**RE: Pikeview Quarry, Permit No. M-1977-211;
Preliminary Adequacy Review for Technical Revision (TR-22)**

The Division of Reclamation, Mining and Safety (DRMS) received a request for a Technical Revision (TR-22) addressing the following:

Updates to reclamation drainage design, reclamation seed/plant species list, and weed management plan based on detailed design, seed/plant availability, and recently identified weeds.

Figure 1. North Terrace Channel Markup Suggestion

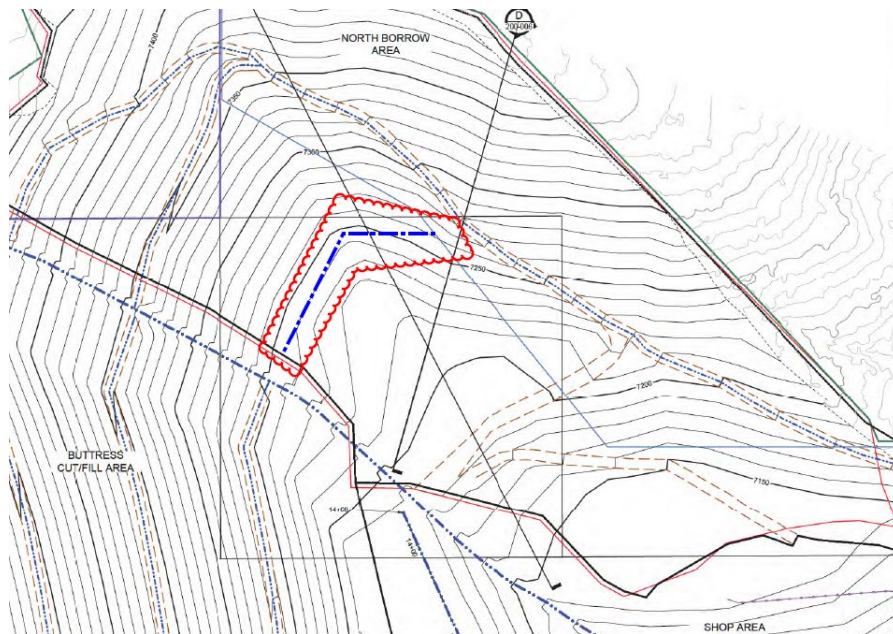
- b. No terrace channel is shown on Drawing 200-004 on the north side of the North Channel opposite where a south terrace channel combines with the North Channel at ~Sta. 18+00 (see Figure 1). Please revise the design or explain why a terrace channel was not included in this area.
